**VALLEY LIGHTS SUBDIVISION TENTATIVE PLAN,  
PLANNED UNIT DEVELOPMENT (PUD), AND  
MAJOR SITE PLAN REVIEW  
STAFF REPORT**

<b>Procedure Type:</b>	Type III: Urban Area Planning Commission	
<b>Project Number:</b>	104-00106-16; 201-00137-16	
<b>Project Type:</b>	Subdivision Tentative Plan, Planned Unit Development (PUD) & Major Site Plan Review	
<b>Owner(s):</b>	TL 400 ~ Pavise LLC; & TL 719 ~ Kendell Ferguson	
<b>Applicant:</b>	Kendell Ferguson and Pavise, LLC	
<b>Representative:</b>	T.J. Bossard Engineering LLC	
<b>Property Address:</b>	543 & 551 NW Valley View Drive	
<b>Map and Tax Lot:</b>	36-05-07-24- 400 & 719 <i>See Exhibits 1 and 2.</i>	
<b>Zoning:</b>	R-1-12 (City)	
<b>Size:</b>	TL 400 ~ 1.63 acres, & TL 719 ~ 7.90 acres	
<b>Planner Assigned:</b>	Lora Glover	
<b>Application Date:</b>	December 13, 2016	
<b>Application Complete:</b>	December 16, 2016	
<b>Date of Staff Report:</b>	January 18, 2017	Due: 1/18/17
<b>Hearing Date:</b>	January 25, 2017	
<b>120 Day Deadline:</b>	April 17, 2017

The proposal is for a 15-lot tentative subdivision plan served by the extension of Pleasant View Drive (a public street) and the creation of a private street (Randy Lane). The application inc

**EXHIBIT 3**

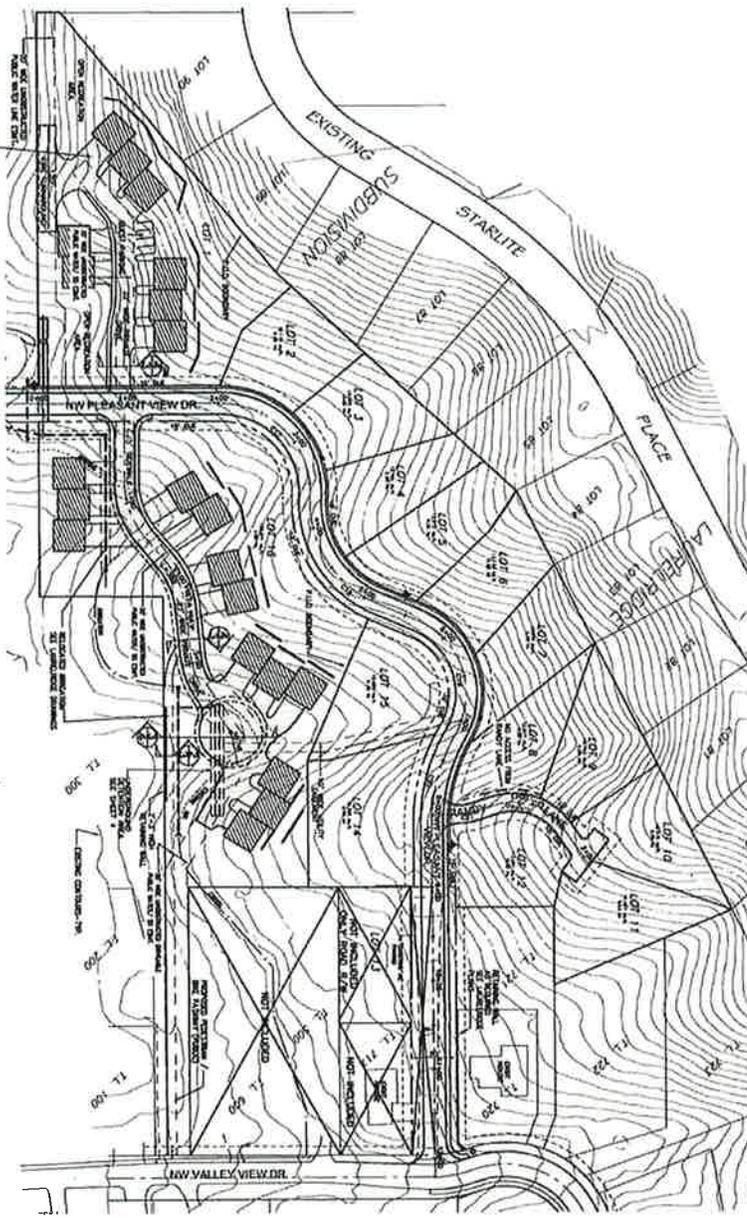
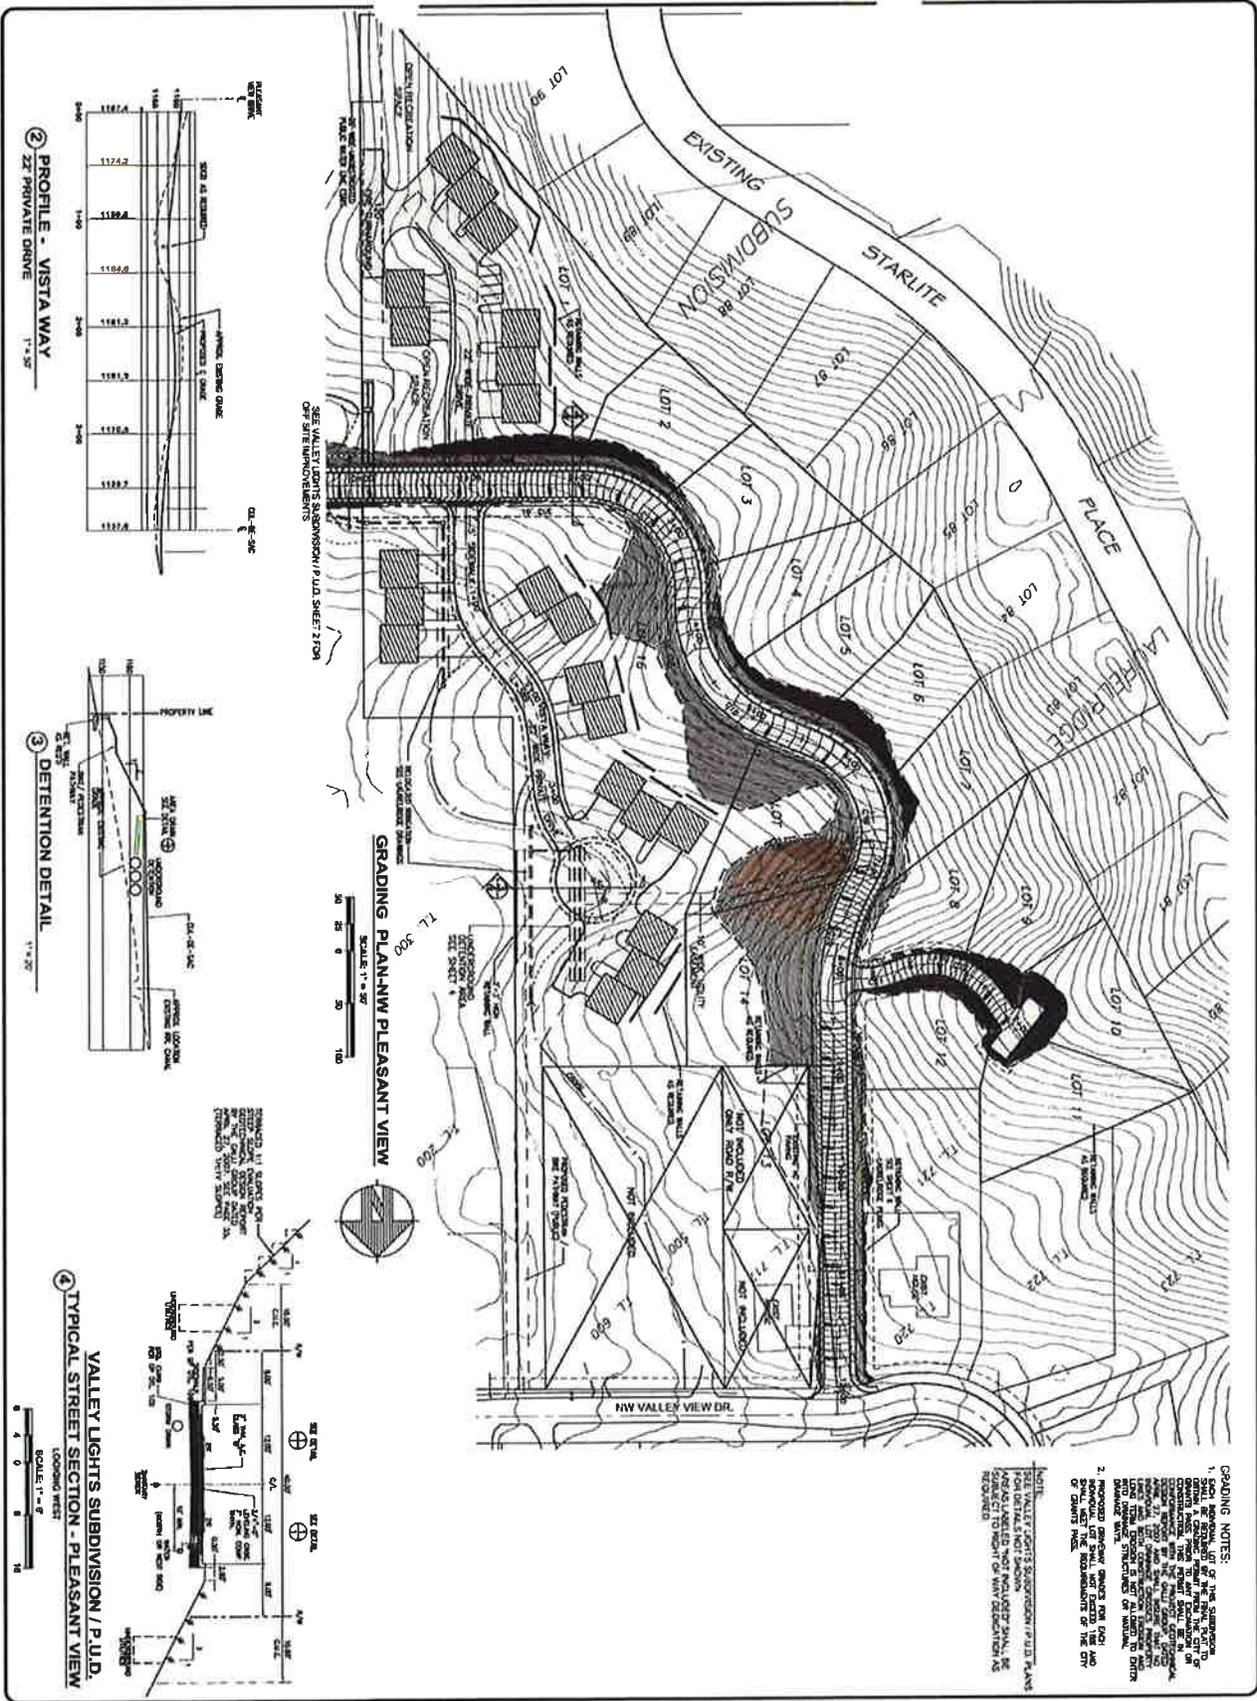
The application proposes only that Lots 1 and 16 are part of the PUD, comprising of 4.19 acres (Sheet 1 of 4). The narrative says 20 units are proposed as part of the PUD, though the site plan reflects 21 units. The R-1-12 zoning allows 3.96 dwellings per acre (which would be 16 units). The proposal exceeds the allowable density without requesting or showing how possible density bonuses would be achieved under Section 18.091(2). In addition, the plan only shows 0.52 acres of proposed open space for the

PUD. Section 18.091(2) allows a density bonus of one dwelling unit per acre for each acre of open space that is provided in excess of the minimum required. The minimum open space requirement for multi-dwelling development in the R-1-12 zone is 40%. Sheet 1 of 4 reflects approximately 0.124% of open space area for the PUD.

**Staff Response: Not Satisfied.** The application proposes only Lots 1 and 16 as part of the PUD, comprising of 4.19 acres (Sheet 1 of 4). The narrative says 20 units are proposed as part of the PUD, though the site plan reflects 21 units. The R-1-12 zoning allows 3.96 dwellings per acre (which would be 16 units). The proposal exceeds the allowable density without requesting or showing how possible density bonuses would be

achieved under Section 18.091(2). In addition, the plan only shows 0.52 acres of proposed open space for the PUD. Section 18.091(2) allows a density bonus of one dwelling unit per acre for each acre of open space that is provided in excess of the minimum required. The minimum open space requirement for multi-dwelling development in the R-1-12 zone is 40%. Sheet 1 of 4 reflects approximately 0.124% of open space area for the PUD.
